Technical Service Bulletin

TSB0314 CX65 Exhaust O'Rings

September 19, 2013

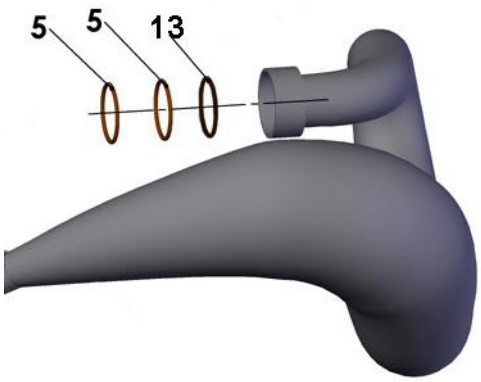
In the picture below, item 13, part number ZCMUOR11 was previously ZCMOTE11 (same as item 5 still used two places).

This new o'ring is larger in diameter, seals better, and remains in position more reliably during installation.
